# TELEPRINTER ANCILLARY WORKING AT OUT OFFICES. TG(L)1040.

## DUPLEX CIRCUIT WITH SWITCH TO RESERVE FACILITY.

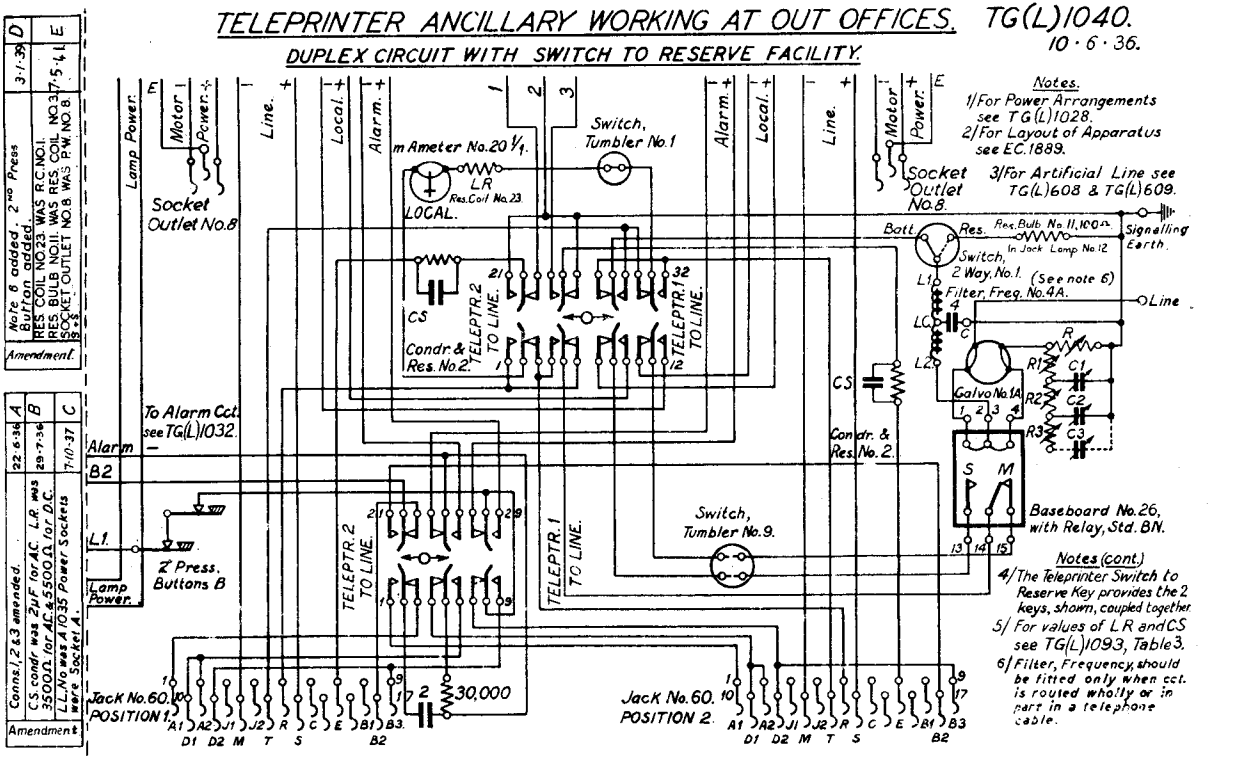
| Amendment | | |
|---|---|---|
| Note 6 added. 2nd Press Button added. | 3·1·39 | D |
| RES. COIL NO.23. WAS R.C.NO.1. RES. BULB NO.11. WAS RES. COIL NO.3. SOCKET OUTLET NO.8 WAS P.W.NO.8. | 7·5·41 | E |

| Amendment | | |
|---|---|---|
| Conns.1, 2 & 3 amended. | 22·6·36 | A |
| CS. condr. was 2μF for AC. L.R. was 350Ω for AC. & 5500Ω for D.C. | 29·7·36 | B |
| L.L. No was A 1035 Power Sockets were Socket A. | 7·10·37 | C |
